London Ranch Estates Subdivision 22PL1186

Request for Plat Waiver for Wastewater Construction

Planning Commission Meeting
April 17, 2024

Exhibit D

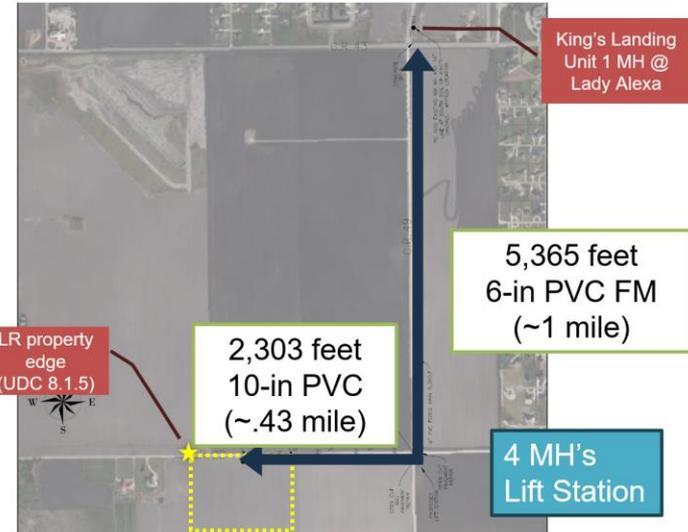
Cost estimate is not valid and should not be considered

Proposed Wastewater Construction Plans

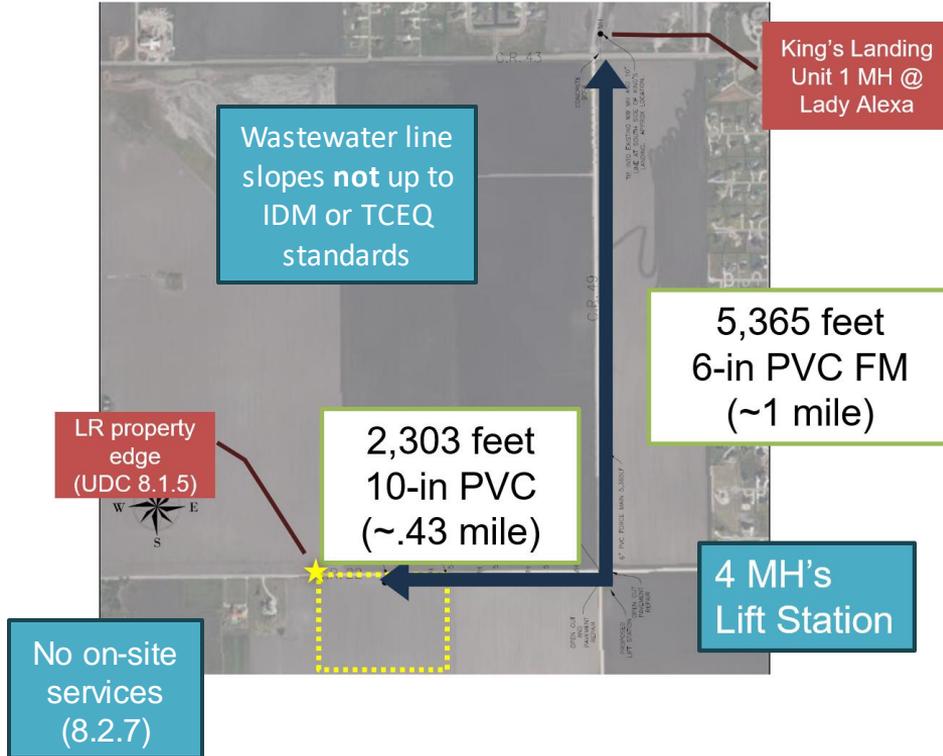
If waiver is denied, proposed plans would **not** be approved

- Design doesn't meet standards
- All lots must have access
- Must provide connectivity
- The distance to the Master Plan connection point is about 5,000 feet less than the proposed connection to the existing manhole

Nearest Master Planned Facilities

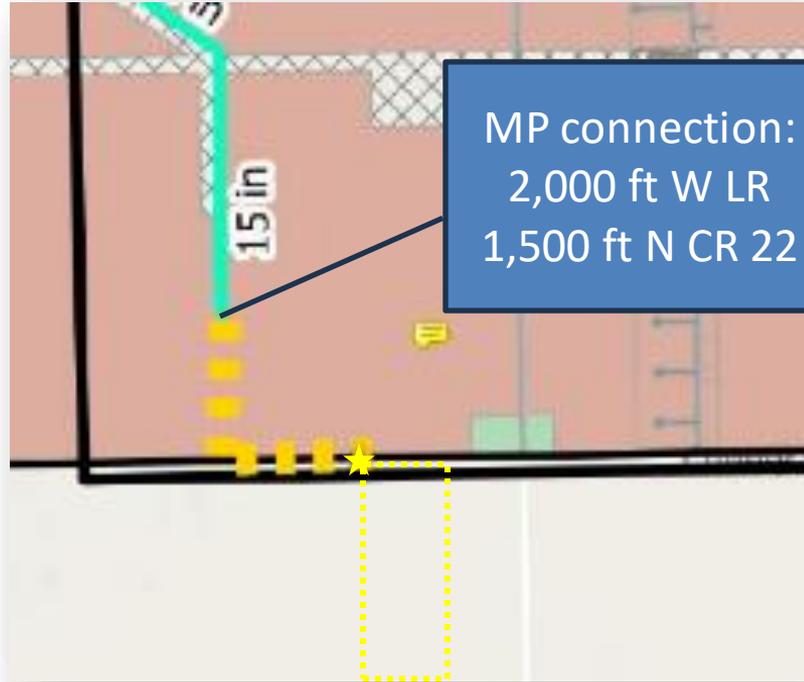
- A cost estimate connecting to the nearest Master Plan connection point has not been provided
- A Master Plan Amendment request has not been submitted for review to city staff
